Lockyer Valley Regional Council: Inland Rail EIS Review – Gowrie to Helidon (G2H)

EIS section and topic	Comment <i>What is the issue or what is suitable within the EIS</i>	Recommendation <i>What changes to the EIS or additional information is required?</i>
Draft EIS General Comments			
1	Draft EIS	<p>Failure to Meet OCG’s Terms of Reference: as with the Helidon to Calvert (H2C) draft Environmental Impact Statement, the draft EIS for the Gowrie to Helidon (G2H) section of Inland Rail consistently fails to meet the requirements of the Office of the Coordinator General’s (OCG’s), Terms of Reference (TOR) for the project. In addition to this, there is a failure to commit to the appropriate consideration and management of both community concerns, and the significant and permanent impacts which the community will experience because of the proposed project in its current form.</p> <p>Technical studies used to inform the draft EIS have been restricted by the use of insufficient or inappropriate study criteria, under-estimated background levels and/or the use of outdated or inappropriate guidelines or procedures. This has contributed to the failure of the draft EIS to meet the requirements

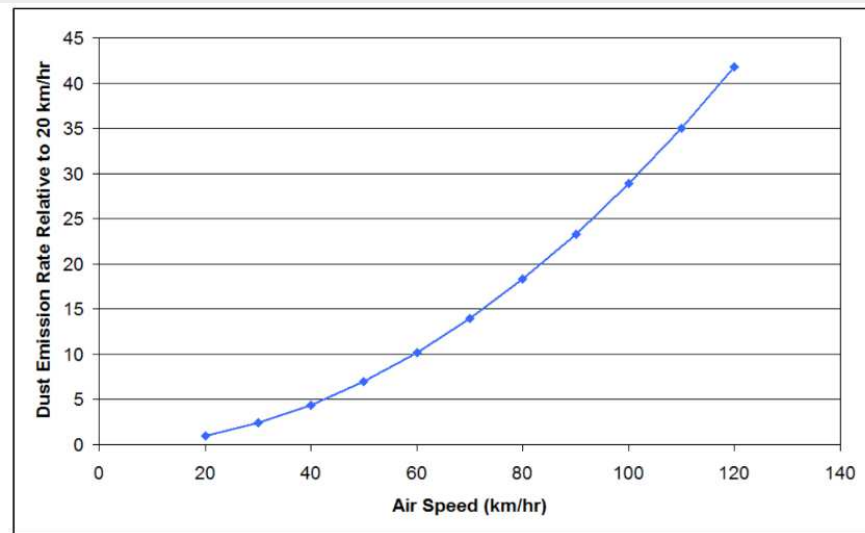
92	Chapter 12 Appendix K Section 7.3 (Assessment of	Assessment of Impacts to Ecological Receptors – Section 7.3 of the Air Quality Technical Report determines impacts from the project on ecological receptors. The key pollutant for consideration is the annual average NO ₂ ground level concentration of 33 mg/m ³ .	The Air Quality Technical Report requires update to provide additional information with regards to impacts to ecological receptors and to meet the requirements of the OCG's TOR.

Impacts to Ecological Receptors)	<p>Observations presented in Section 7.3 suggest an exceedance of the assessment criteria outside the permanent disturbance footprint area. Moreover, the exceedance is largely attributed to traffic on the Toowoomba Bypass. However, as mentioned earlier, there is no clear information on the modelling of emissions from the Toowoomba Bypass.</p> <p>As-such, there is a level of uncertainty associated with the impacts predicted at the ecological receptors.</p> <p>Further, there is no discussion on mitigating the exceedances predicted to the ecological receptors (although the exceedance is restricted to limited areas outside the proposed project’s permanent disturbance footprint). Given this, the draft EIS fails to meet the requirements of TOR 5.1 and 11.128.</p>	
93	Chapter 12 Appendix K (Section 7.5 Agricultural Train Odour Impacts)	<p>Agricultural train odour impacts – Section 7.5 of the Air Quality Technical Report identifies livestock freight trains as presenting the greatest risk of nuisance related to odour emissions, when compared to agriculture freight. The potential for offensive odours is especially quite high when stopping at crossing loops. Assessment of odours has been conducted using the FIDOL factors Table 7.8 of the Air Quality Technical Report makes a note that the odour intensity from livestock freight trains is expected to range from strong to very strong. Taking into consideration the strong odour intensity coupled with longer durations at crossing loops, a qualitative assessment of odour impacts would not deem fit and appropriate for a project of this magnitude.</p> <p>In other jurisdictions such as NSW and Victoria, odours are assessed on a sub-hourly timescale and trains with a strong to very strong odour intensity idling / stopping for a period of one hour or less has a considerable potential to generate adverse odour impacts on the surrounding community.</p> <p>The assessment of odour impacts does not meet TOR 11.131 as the assessment does not:</p> <ul style="list-style-type: none"> - Adequately consider cumulative impacts of odour at receptors. If the population is already exposed to similar (livestock) odour from local agricultural activities, what impacts may occur to amenity from adding an additional odour source – which is similar in character. - The assessment does not take into consideration the assimilative capacity with regards to livestock odours. - It is assumed that the 6 livestock trains would be spread over a 1-week period, resulting in an average of less than 1 train per day. However, there is no 	Appendix K requires update to include a revised approach for the quantitative assessment of agricultural/freight train odour impacts in order to meet the requirements of TOR 11.131.

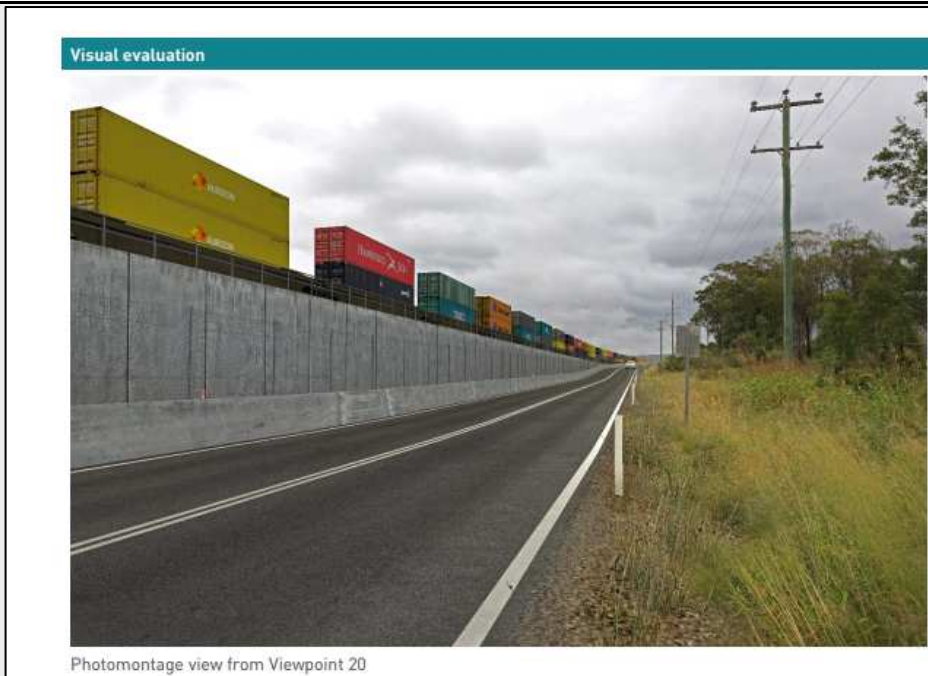
Chapter 18 Cultural Heritage			
156	Chapter 18: Cultural Heritage	The EIS states that indigenous cultural heritage will be managed under the CHMP's (CLH017009) for the project which was developed in 2018. Local first nations people within the Lockyer Valley have recently discovered a significant amount about their cultural history through connecting with Country, training and collaboration with other first nations groups. LVRC are concerned that the CHMP written in 2018 may not incorporate all current knowledge. Below is an example: Extract from the <u>Lockyer Valley Natural Resource Management Strategy 2020-2030</u> : Written by Larena Thompson. <i>"Lockyer Valley was a part of the main pathway by which Original People and their neighbours journeyed to and from the triennial Bunya Mountains Gathering. The Bonyi Bonyi Gathering was of immense significance to all peoples of southern Queensland and northern New South Wales. It was a gathering for feasting, trade, competitive sport and corroboree contests, sharing of news, tournaments to settle inter-tribal affairs, and arranging marriages. Multuggerah is one of the definitive examples for Yugara People's survival, his story and the many warriors and warrioresses fighting beside him is testament as to why we are here today. When settlers started to move into the area, many important inter-tribal strategies were discussed and decided at the Bonyi Bonyi</i>	Update the EIS to incorporate the significant first nations pathways, cultural sites and history (particularly Multuggerah).

<p><i>Gathering. It was trips back and forth across this Ancient Traditional Pathway that played a big part in organising the inter-tribal tactics Multuggerah used. All over Australia, Originals tracks were the only and best routes through the land; they smoothly followed the ridges, valley floors and waterways and linked waterholes or other resources that travellers needed. Many main roads (e.g. Toowoomba Second Range Crossing - Multuggerah Way) largely follow ancient Original pathways, and over time they became dray and horse riding tracks, then roads and railways, and eventually highways. Everywhere along these routes, stone scatters and scarred trees still attest to their frequent journeying. Even though colonialism deeply affected Yugara in Lockyer Valley and surrounds, we maintain our stories, culture and connection physically and spiritually to our Ancient homelands, this is important for our past, present and future generations¹⁸.”</i></p> <p>Ref ¹⁸.Kerkhove, R (2016), Multuggerah and Multuggerah way, Commissioned by Jagera Daran</p> <p>The Cultural Heritage Chapter of the EIS does not mention “pathways”, “Multuggerah” or “Bunya Mountains” and therefore it is unknown if the EIS incorporates local first nations cultural heritage values or meets the requirements of the TOR “<i>The construction and operation of the Project aims to ensure that the nature and scale of the Project does not compromise the cultural heritage significance of a heritage place or heritage area</i>”</p>

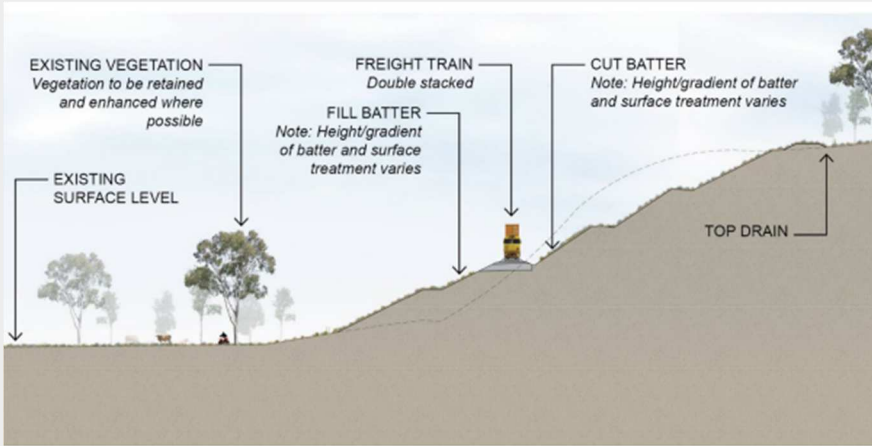
199	Section 23.15.3.1 (Environmental Outcomes)	<p>Environmental Outcomes: Section 23.15.3.1 downplays the required rehabilitation of all affected waterways and associated creek crossings, by stating that 'project works are designed to minimise vegetation loss and mitigate impacts through appropriate rehabilitation.' 'Project works are designed to minimise impacts on the visual amenity of watercourses.' 'The design of rail infrastructure and associated landscape treatments (including slope and stabilisation measures) responds to the natural and rural</p>	<p>The draft EIS requires update to include a wider scope of rehabilitation to all impacted waterways to provide a legacy of landscape renewal which goes above the constraints of the existing site condition and extent of the Project works.</p>

landscape, topography and landform, to the greatest extent possible, while complying with engineering design standards and legislative requirements’ and that the ‘project design results in a minimal maintenance landscape.’ As a result, the document fails to meet the requirements of TOR 5.1, which requires the proponent to ensure that ‘all relevant environmental, social and economic impacts of the project are identified and assessed, and to recommend mitigation measures to avoid or minimise adverse impacts...’	<p>This will require significant site preparation beyond the immediate disturbed areas, treatment and then ongoing maintenance and monitoring for a successful revegetation outcome.</p> <p>This is therefore not a ‘minimal maintenance landscape’ but a rehabilitated landscape which will be sustainable and ultimately self-regenerating. Revegetation requires a significant level of maintenance to be successful, primarily regular watering until established (12-18 months min.).</p> <p>By focussing on drainage line/creeks within the proposed project footprint and beyond, there may be improved success rate of revegetation due to the higher ground moisture content to sustain growth. This then creates the catalyst for ongoing riparian corridor improvements.</p>
